**RFB-2024-65**  
**SUNY SCCC CST BUILDING LOBBY AND BATHROOM RENOVATIONS**  
**C2 DESIGN GROUP**

**ADDENDUM #1**

Issued Date: 12/5/2024

A400

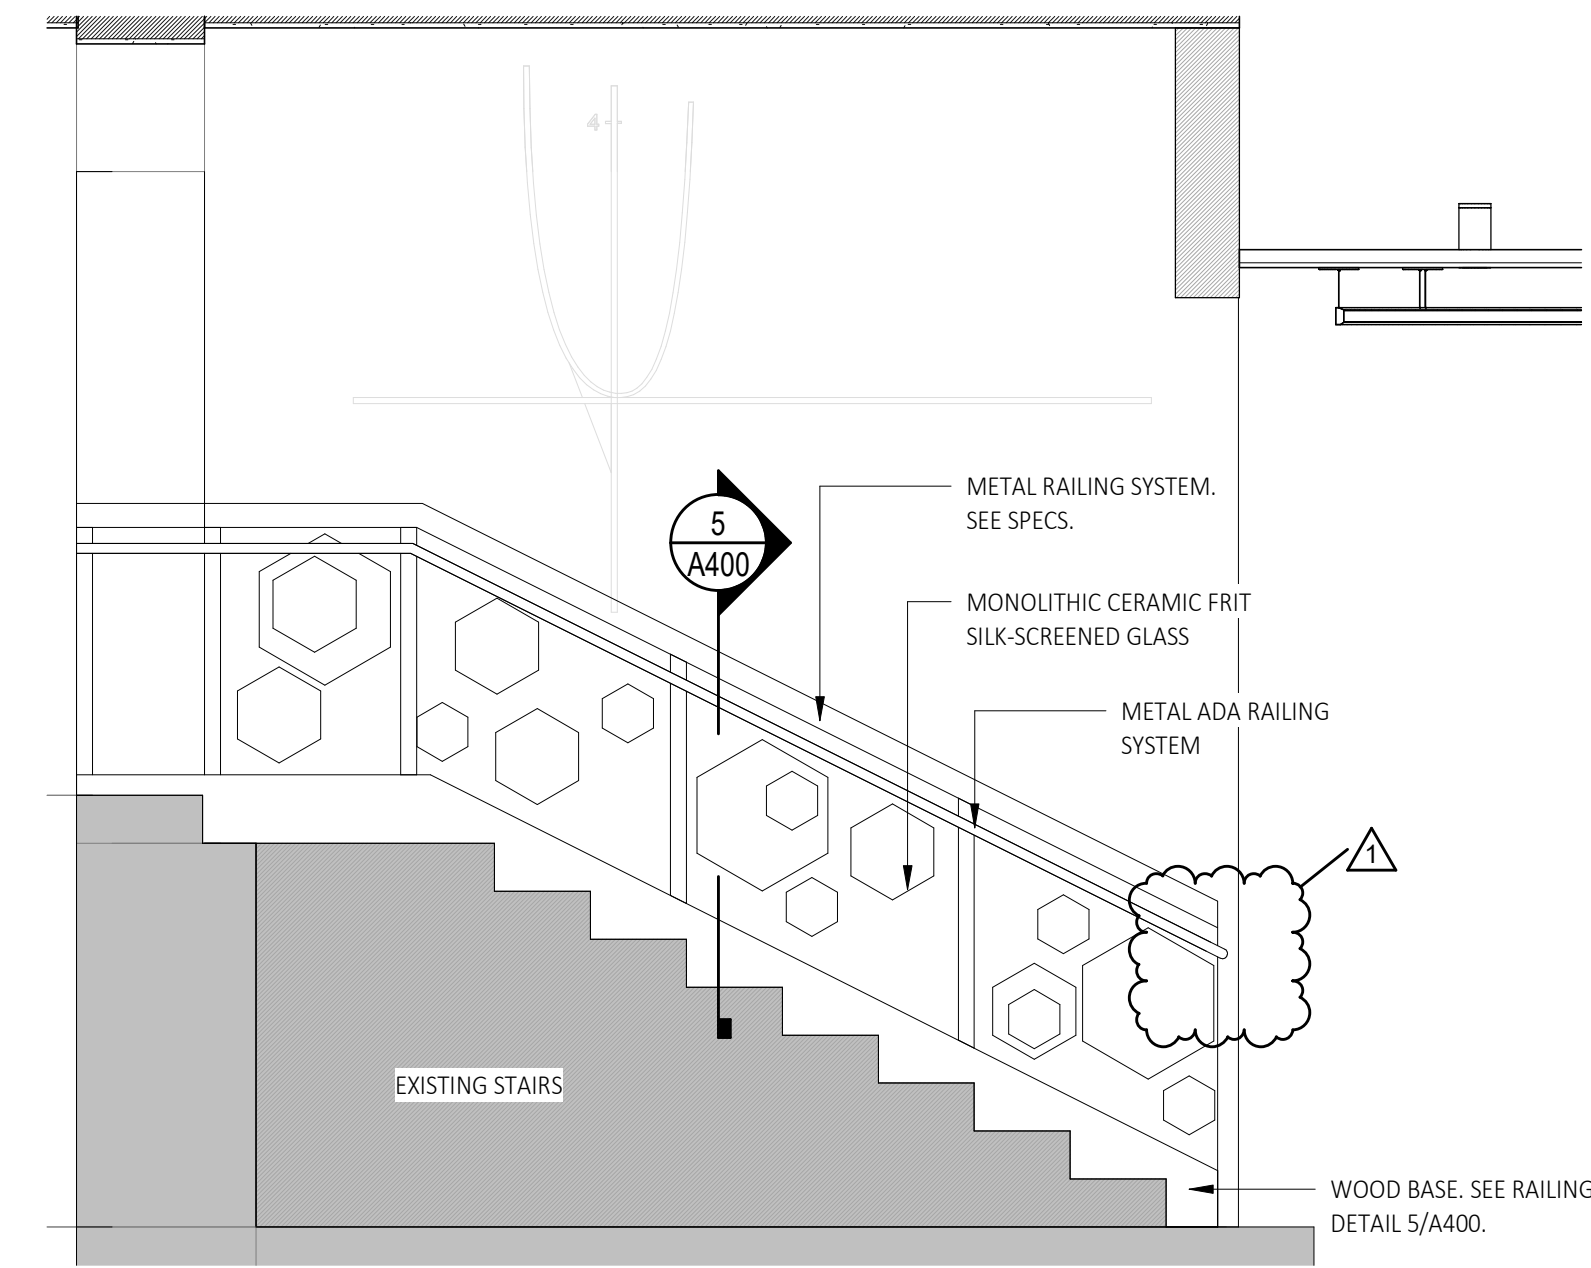
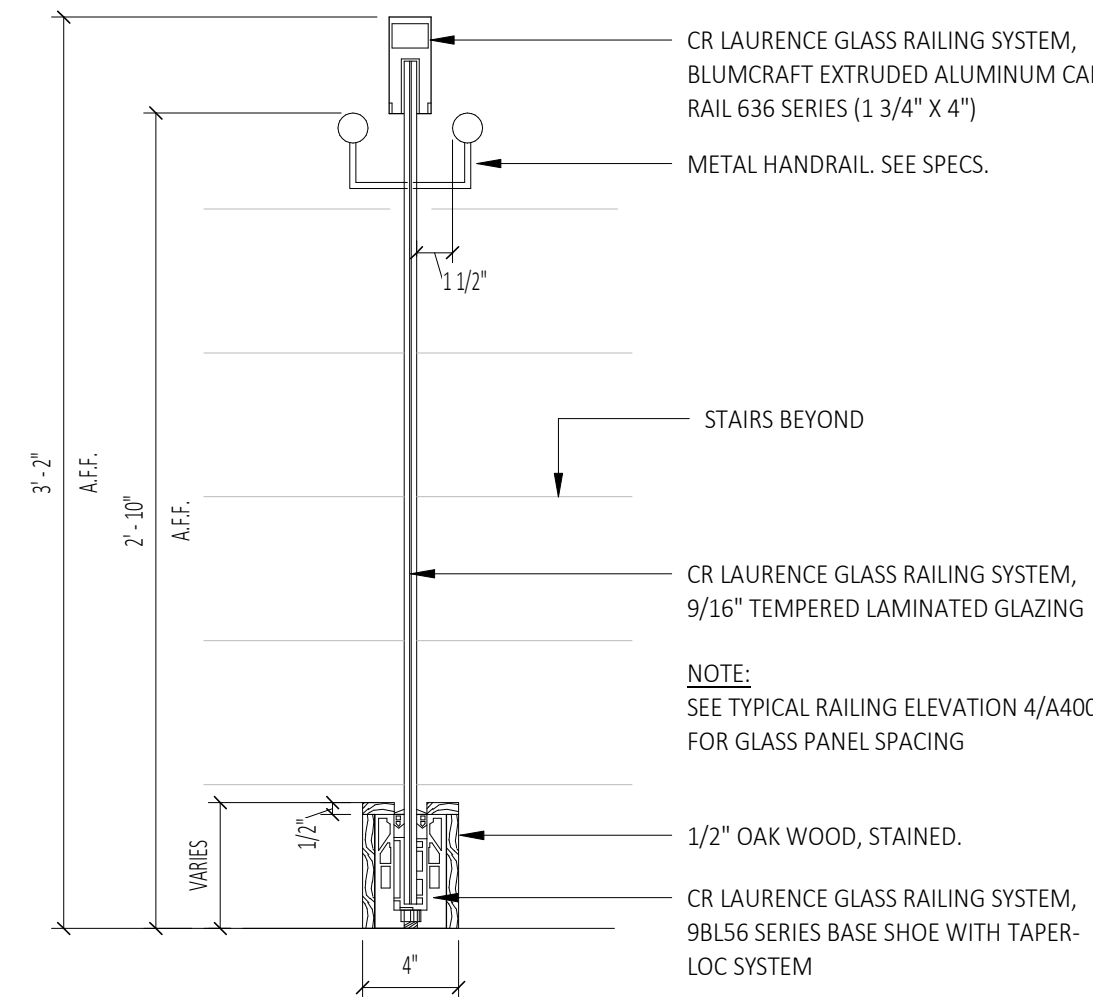
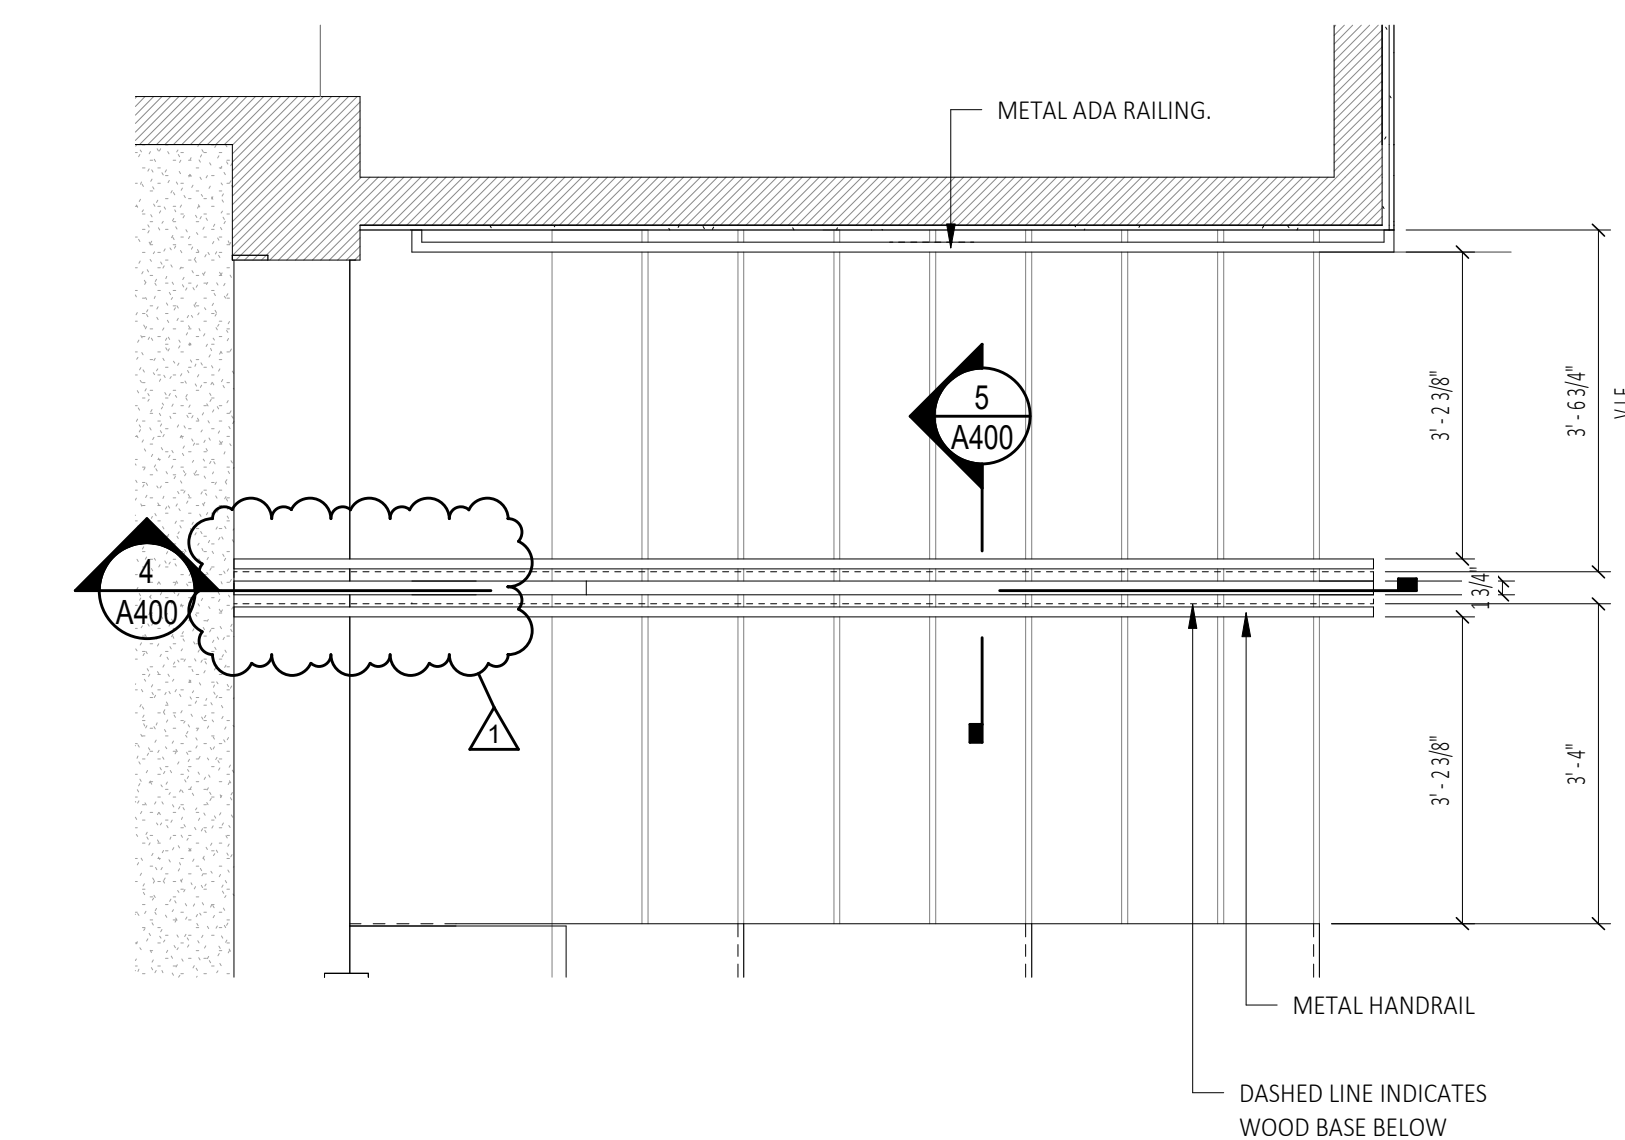
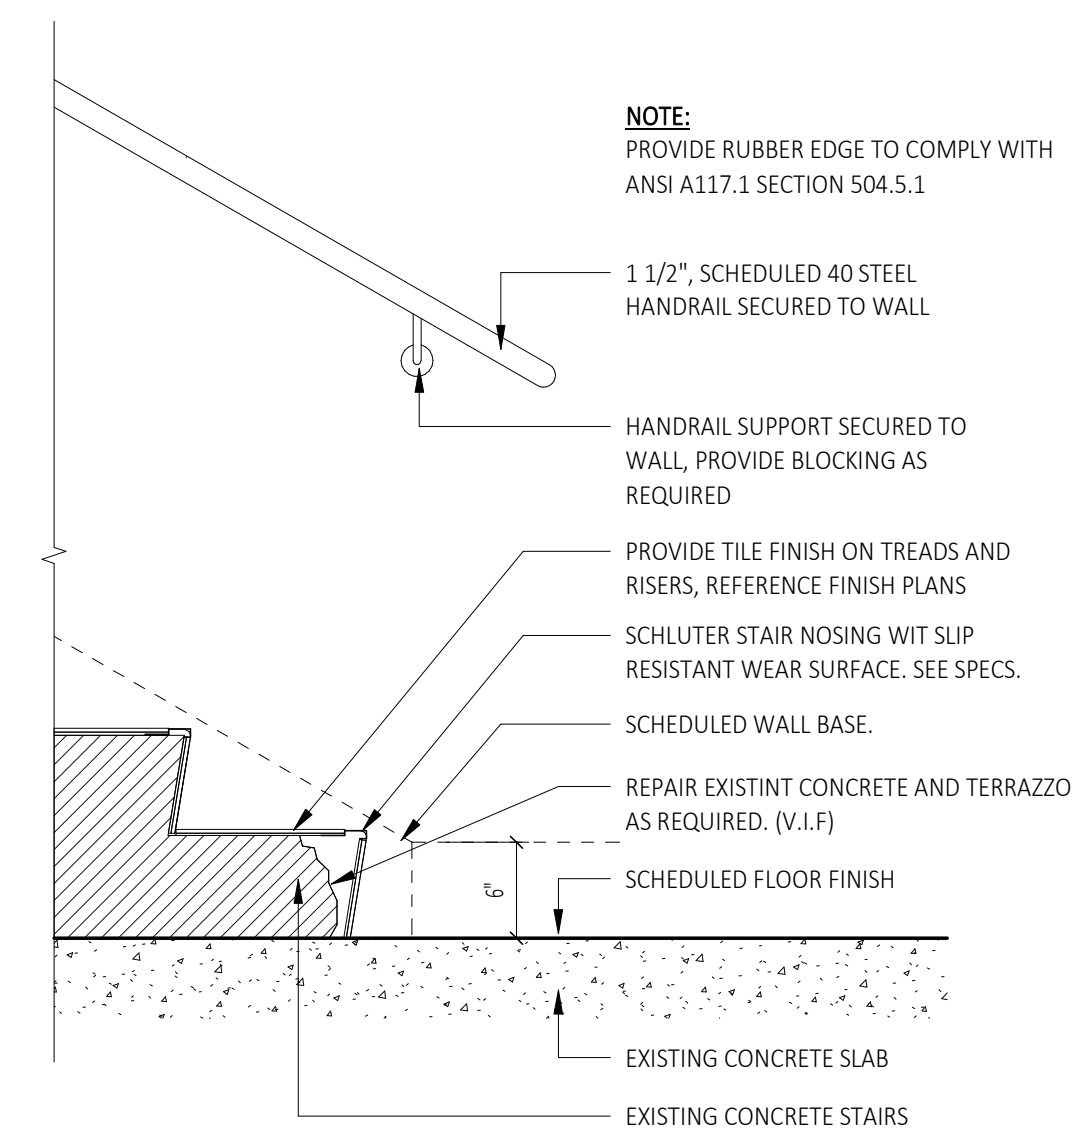
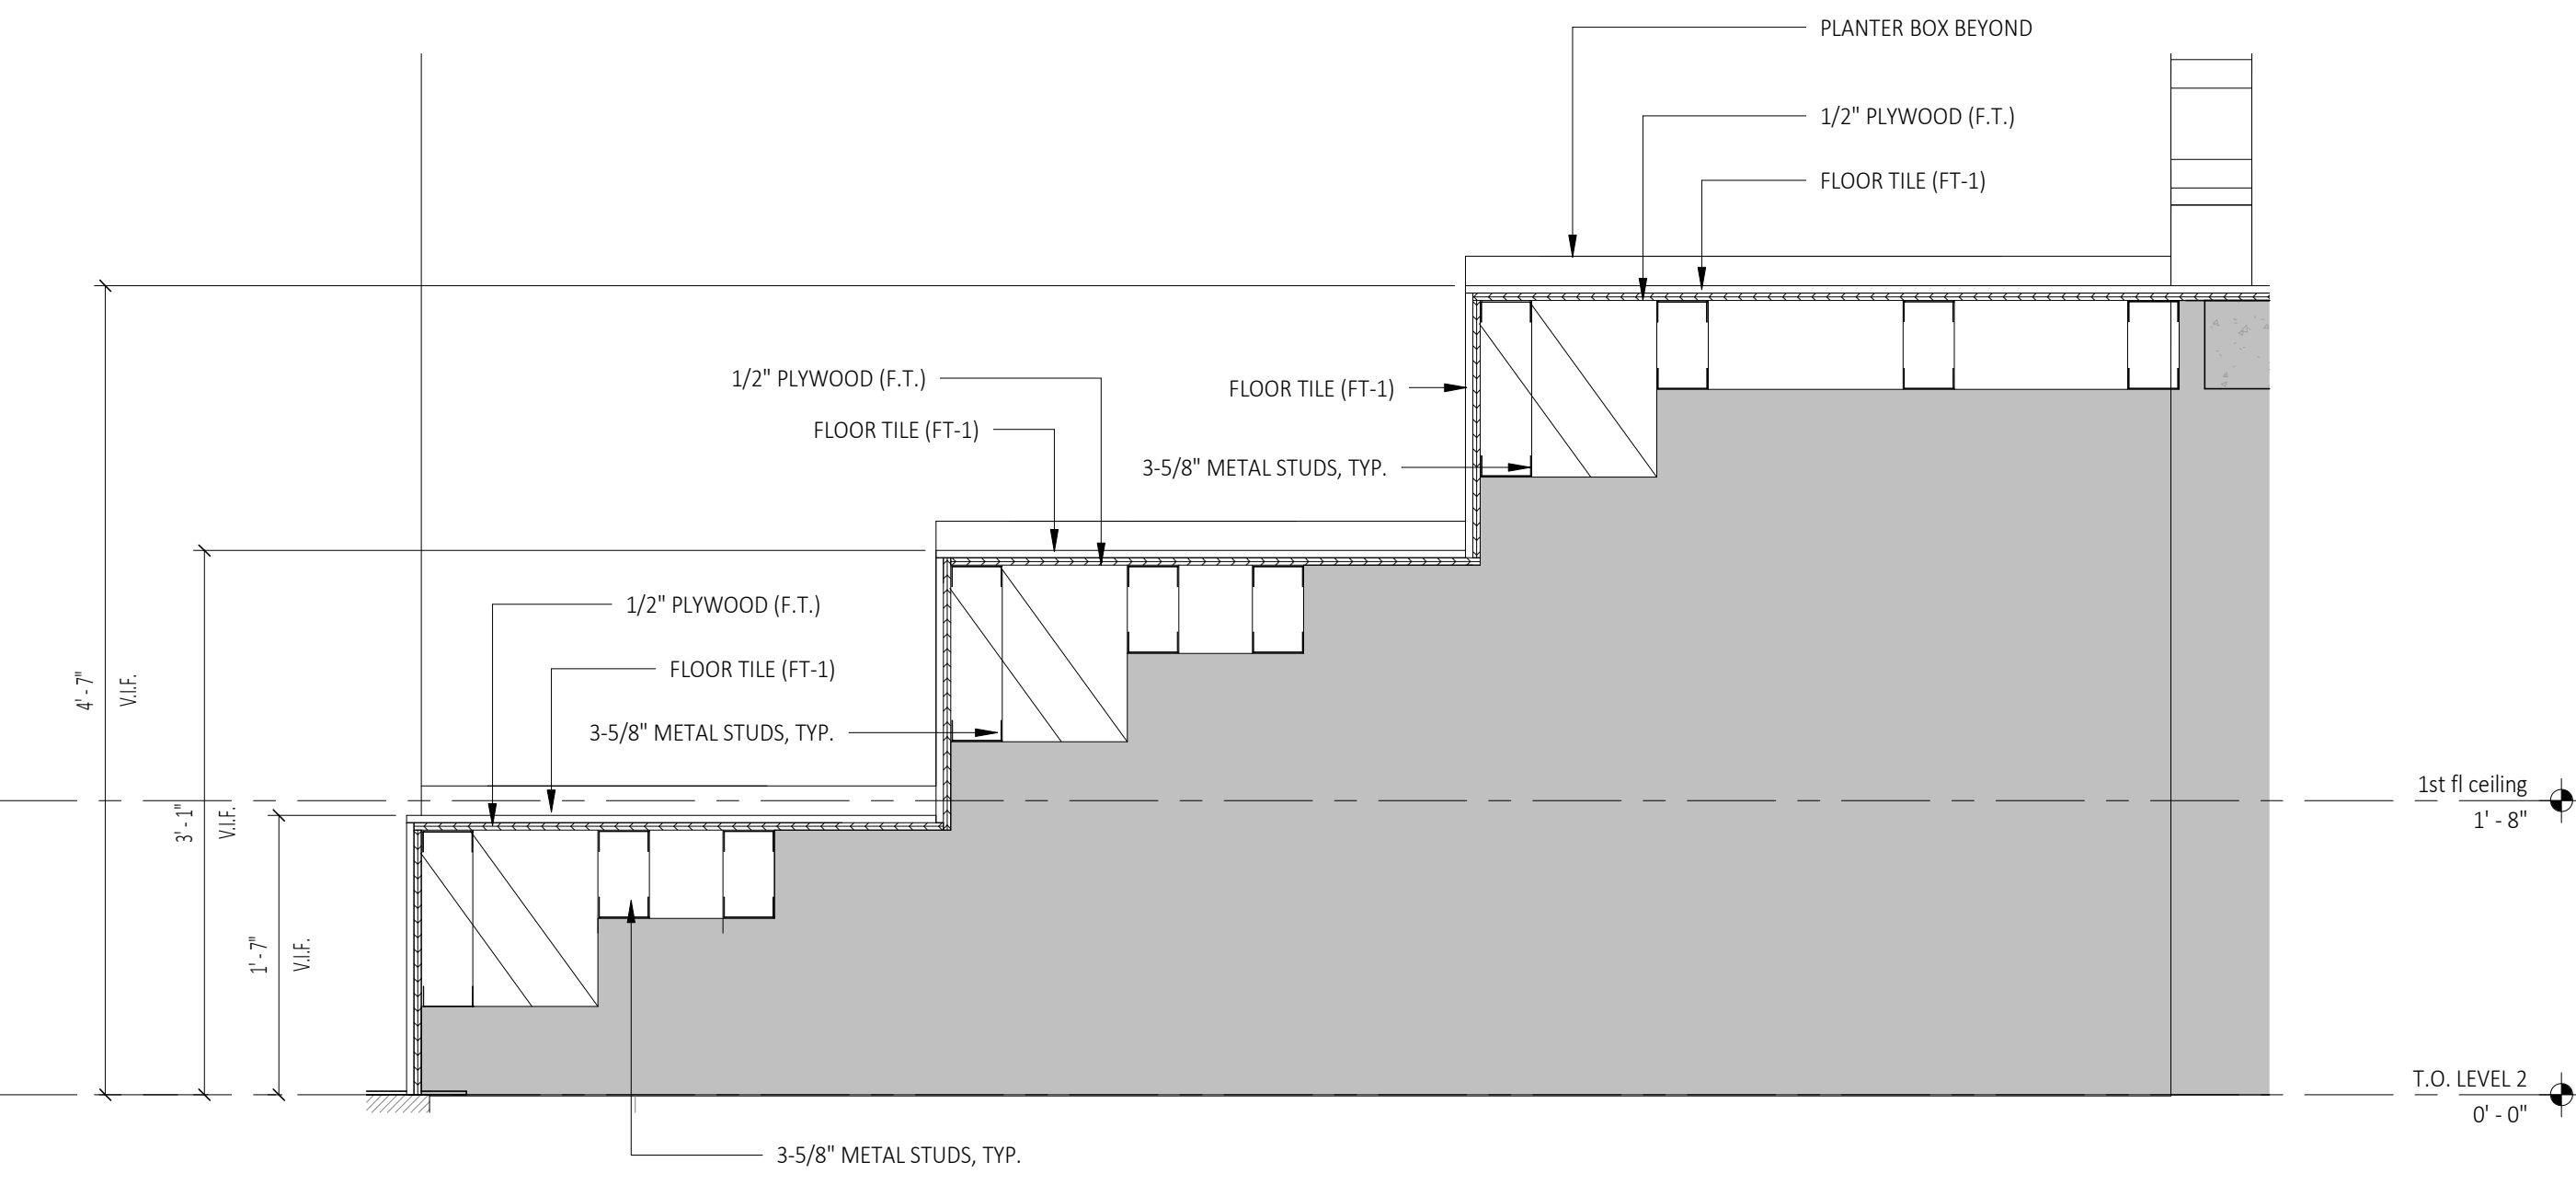
5. Drawing A104 – Roof Plan and Details
  - a. Revisions as marked Addendum #1
6. Drawing A200 – Building Elevations
  - a. Revisions as marked Addendum #1
7. Drawing A400 – Stair Sections
  - a. Revisions as marked Addendum #1
8. Drawing A500 – Exterior Details
  - a. Revisions as marked Addendum #1
9. Drawing A701 – Interior Elevations
  - a. Revisions as marked Addendum #1
10. Drawing A900 – Schedules
  - a. Revisions as marked Addendum #1
11. Specifications 08 41 13 – Aluminum Storefront Systems
12. Specifications 08 71 00 – Door Hardware
